**Site Plan 8-98001G
& 8-02014B**

Staff Report

MEMORANDUM

REVIEW TYPE: **Site Plan Review**
CASE #: **8-98001G and 8-02014B**
PROJECT NAME: **Clarksburg Town Center Phases I and II, Manor Homes**
APPLYING FOR: Approval of 58 multifamily dwelling units inclusive of 10 MPDU's
REVIEW BASIS: Div. 59-D-3 of Montgomery County Zoning Ordinance

PARKING PLAN MANOR HOUSE - BLDG. # 11 CLARKSBURG TOWN CENTER

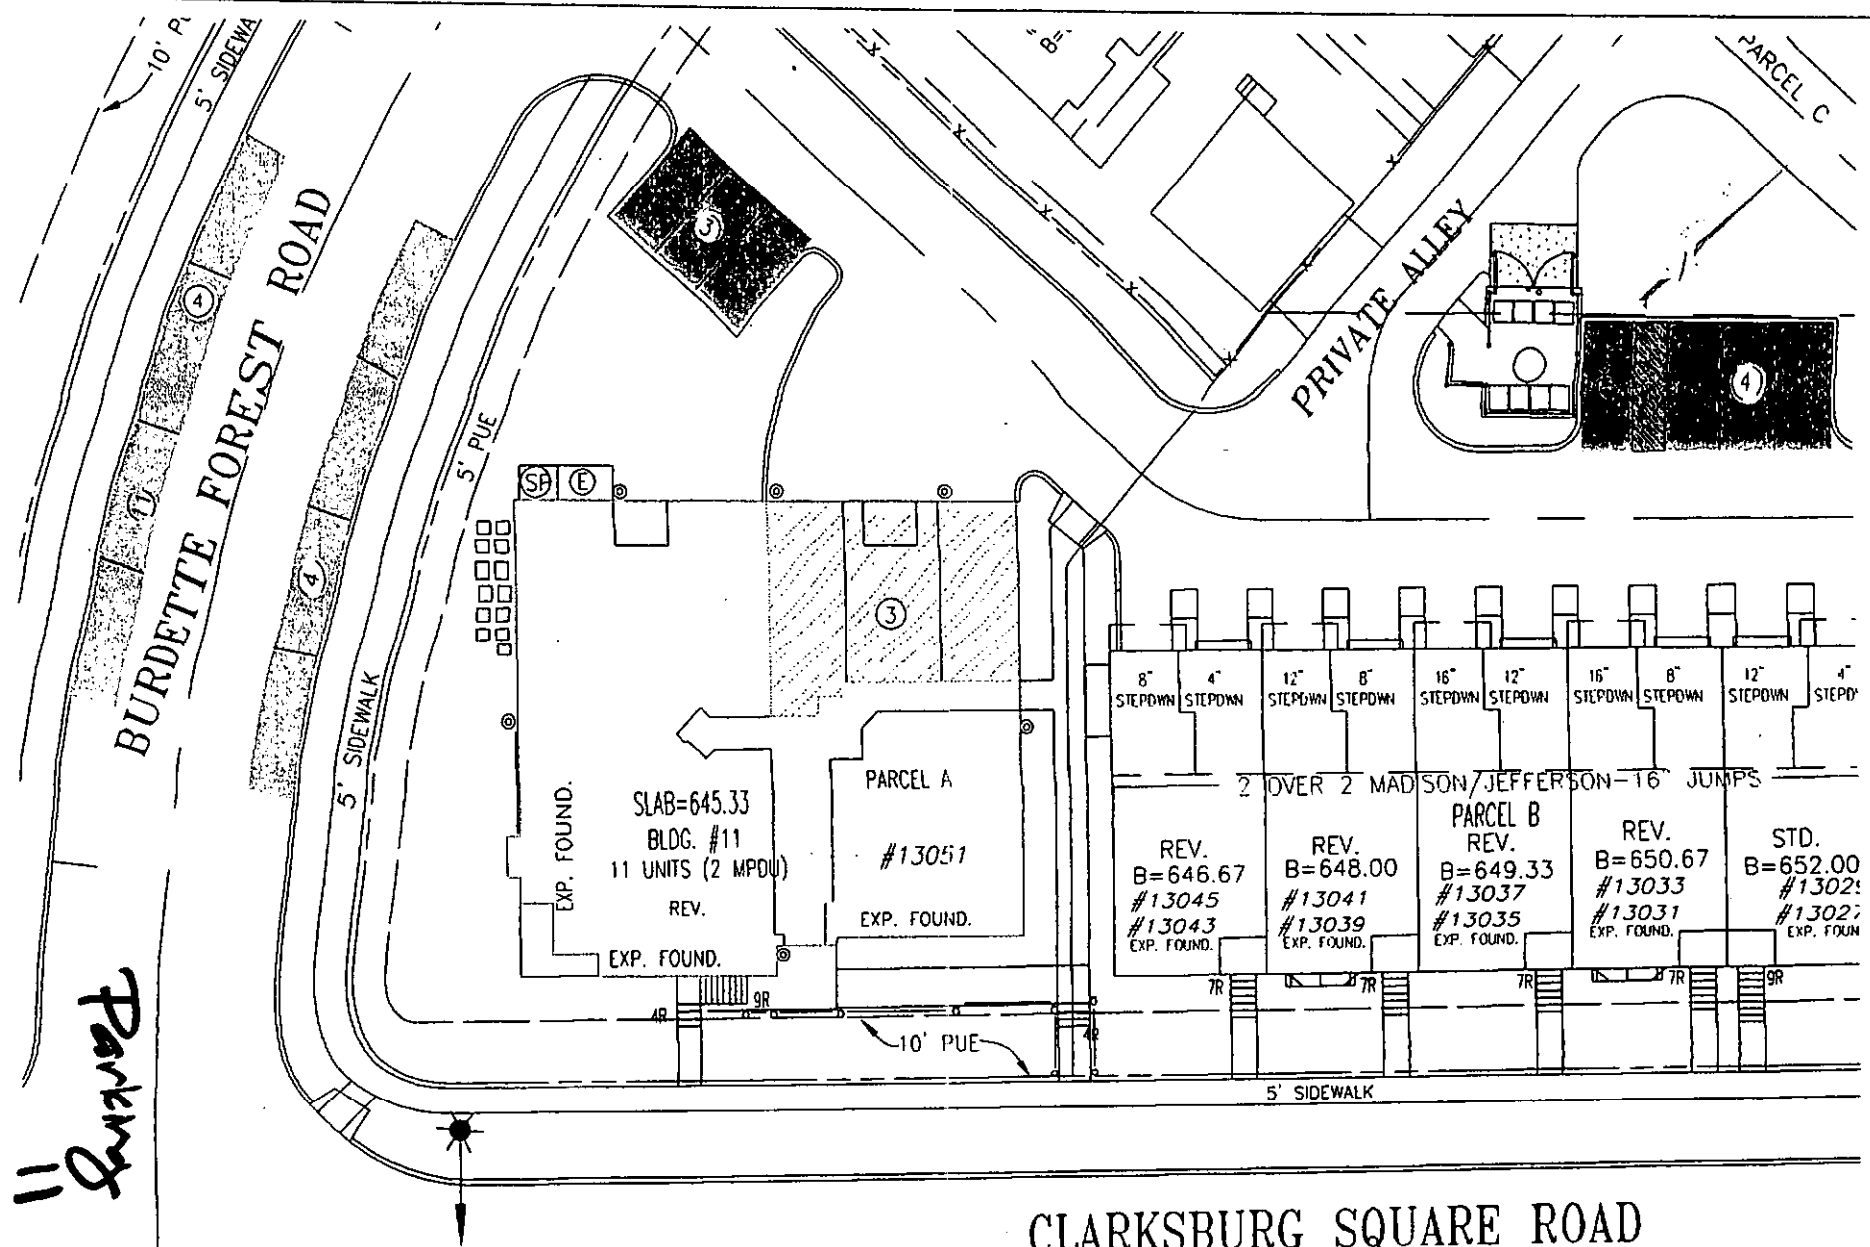
Access points to the site are to be provided consistent with the grid based neotraditional street pattern that was approved with earlier site plans. On-street parking for Building #3 has been expanded with parallel parking on both sides of the internal drive adjacent to Clarksburg Road. The garage of Building #11 has been reoriented to minimize views of the parking areas from the adjacent greenway trail area.
